SUMMIT APARTMENT
LEE'S SUMMIT, MISSOURI
STEEL BEAM FIREPROOFING - INSPECTION

Activity Discrepancy

23-1037
Summit Square III Apts (Insp/Test)
800 NW Ward Road
Lee's Summit, MO

Site Observation Report

1st Floor Segment G middle column
along grid line 43.1

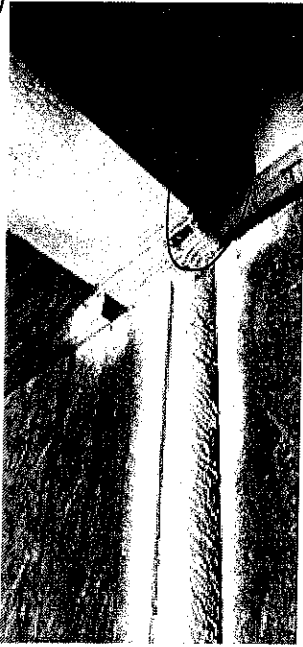
45

- chip in paint

1st Floor Segment G west column
along grid line 43.1

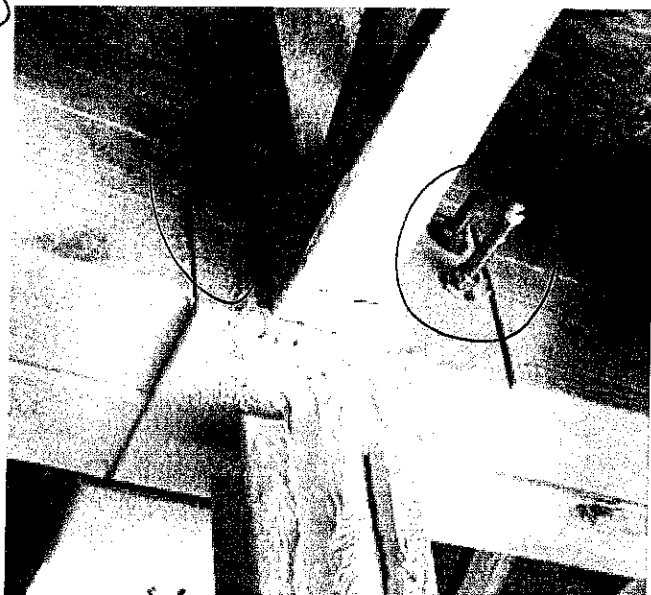
47

- Bolts need to be painted

48

1st Floor Segment G east column along
grid line 42.1

- chip paint out bottom of column

Basement Segment G along
~ grid line H.5

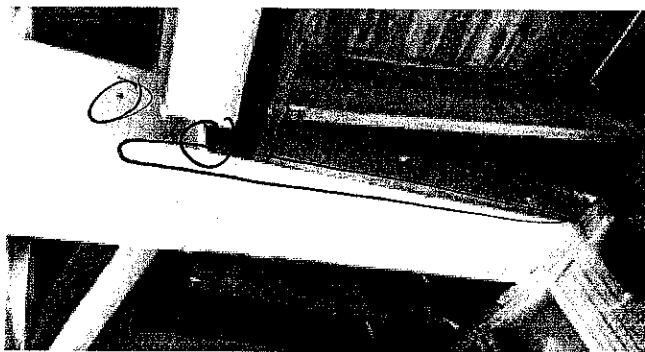
50

- chipped paint

Basement Segment G along
~ grid line 1.1

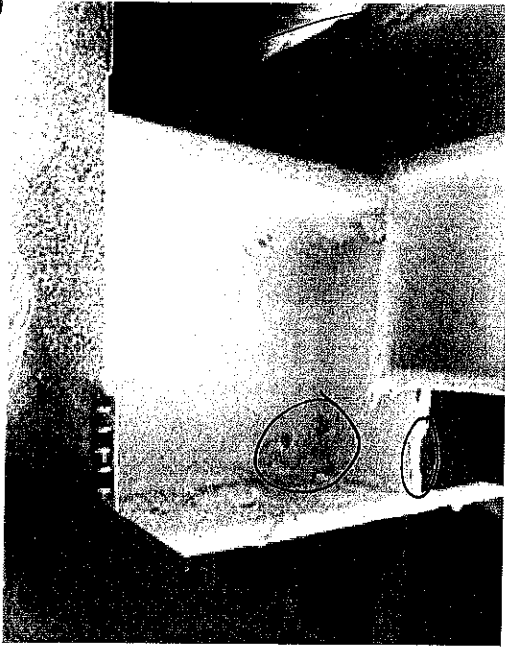
51

- Bolts need to be painted

- chipped paint

Basement Segment G along
grid line 1

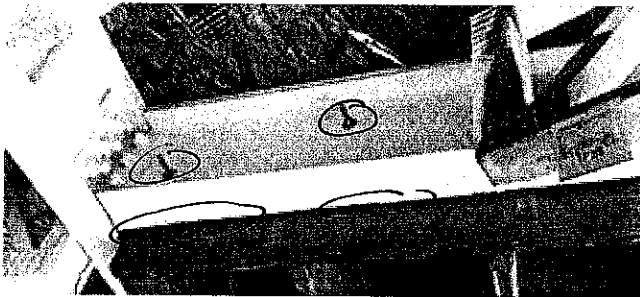
53

- Bolts need to be painted
- chipped paint

Basement Segment 6 along
~ grid line H.5

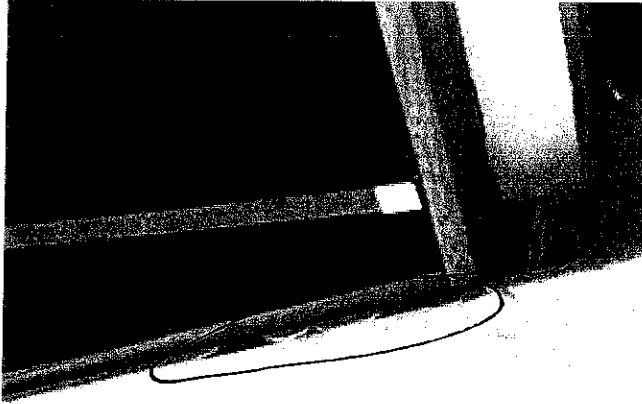
54

- chipped paint

Basement Segment 6 along
~ grid line H.3

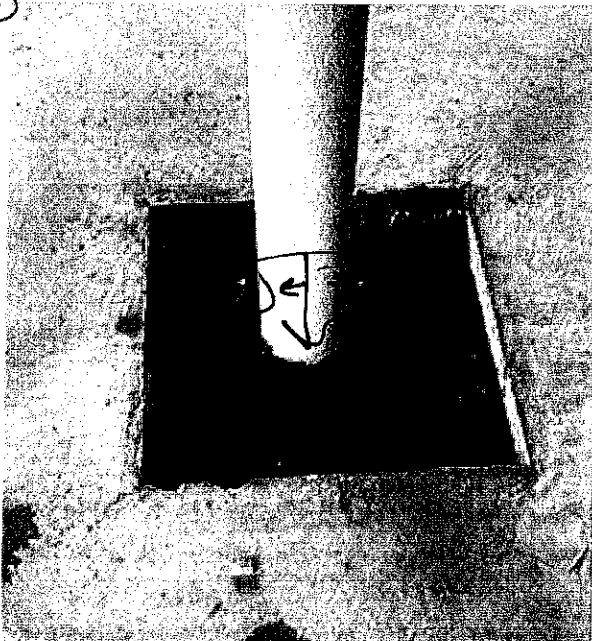
55

- Bolts need to be painted
on the beam

56

Basement Segment 6 column
on grid line H.1

- water needs to be pumped
out the the bottom/base
needs to be painted

Basement cylinder 6
along grid line 12

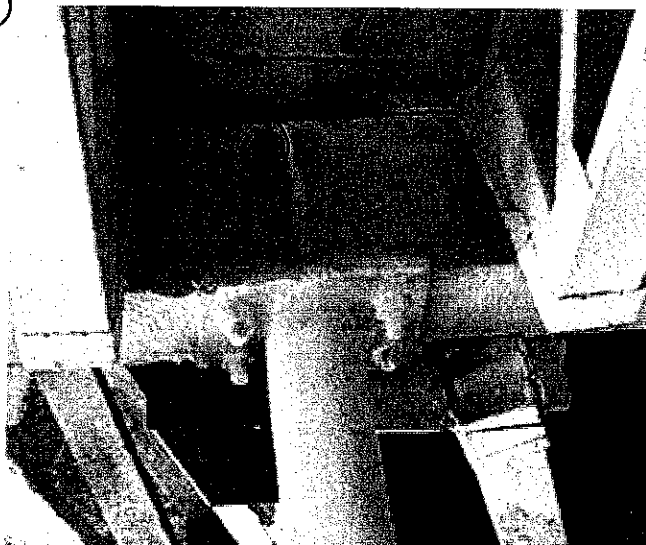
(57)

— Water needs to be pumped
out & base needs to be
painted

(58)

— Exposed steel

Basement Segment G
east column in hallway wall

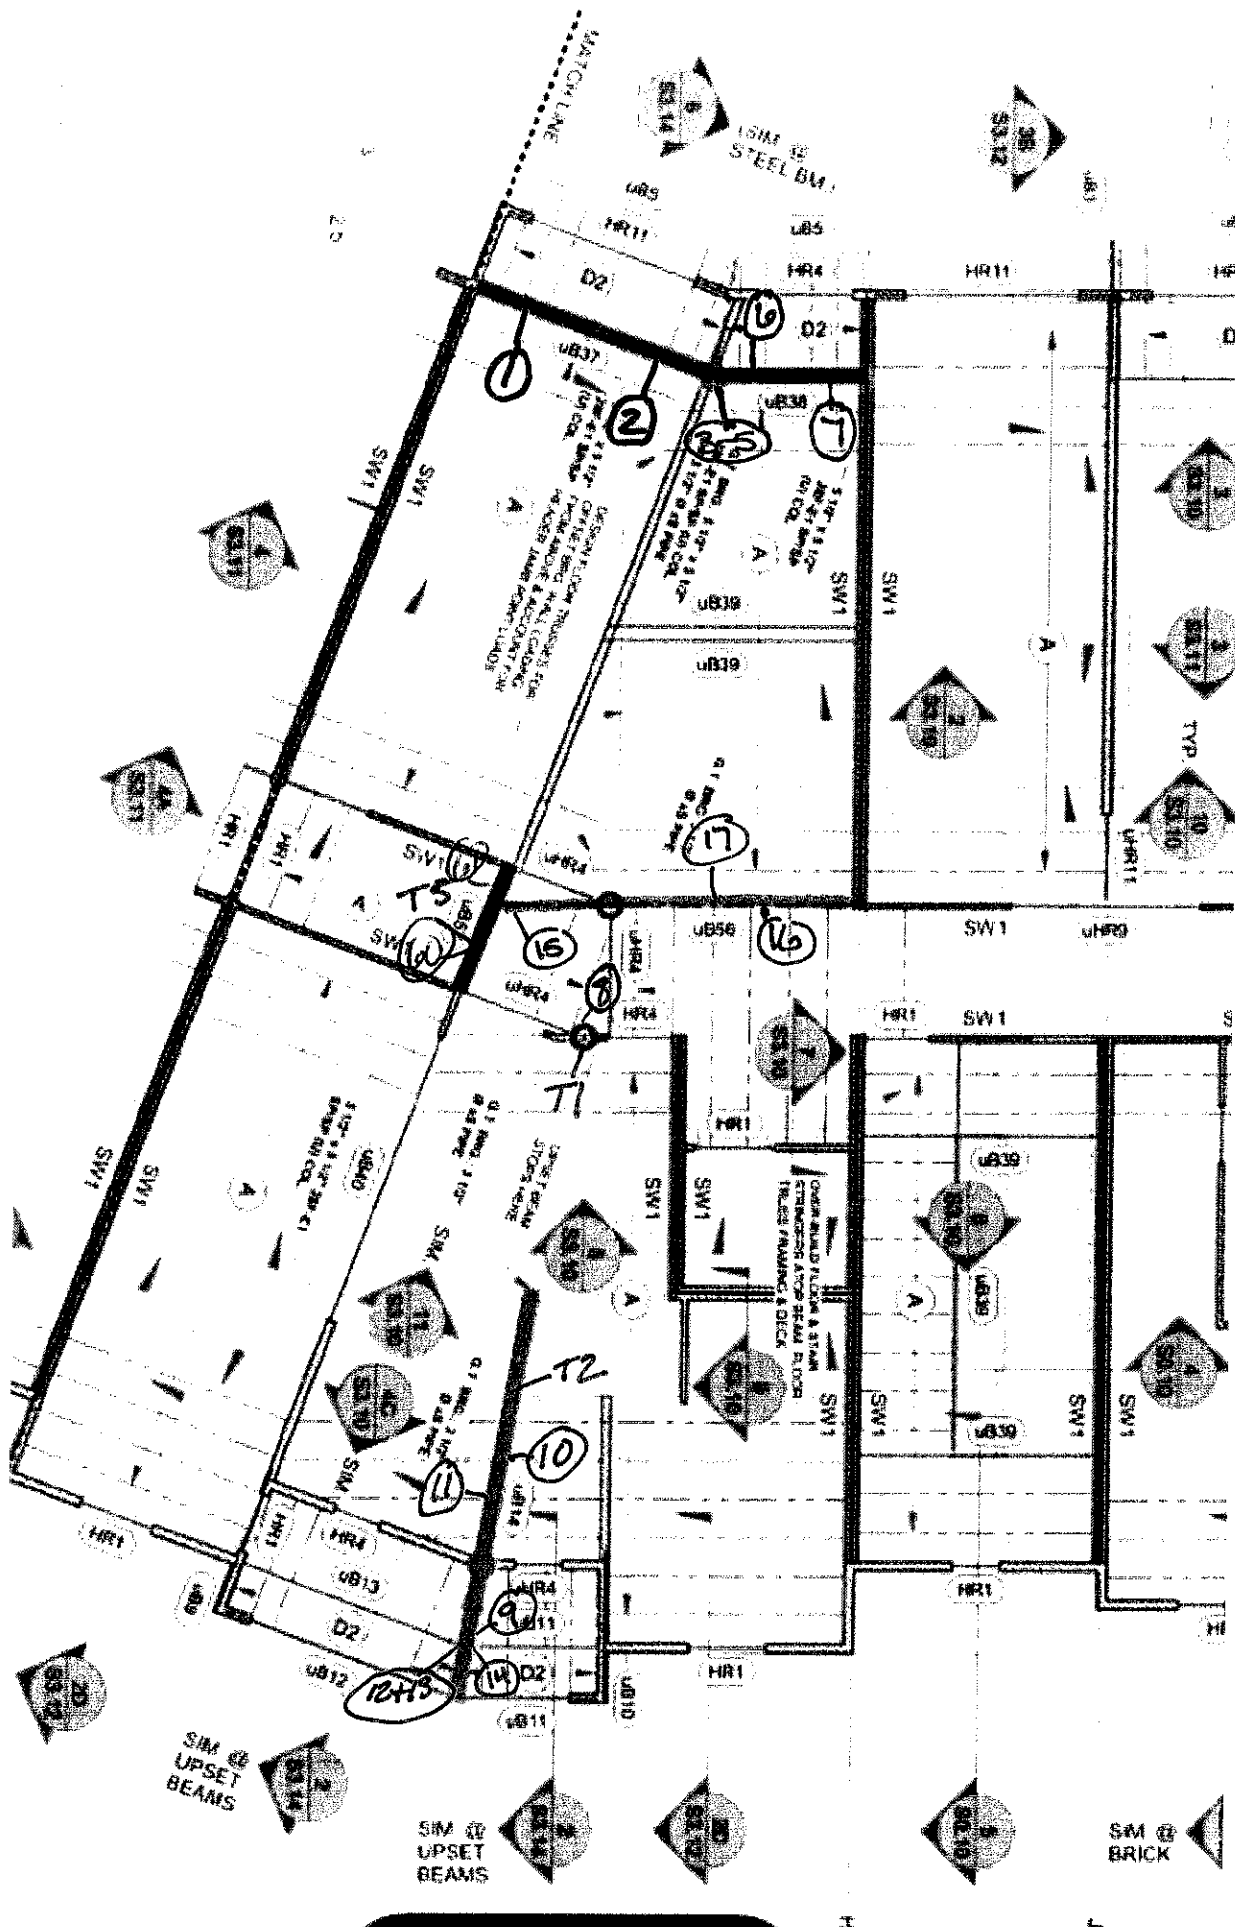
- exposed steel

(61)

- Exposed steel at wood
beams at top of
column
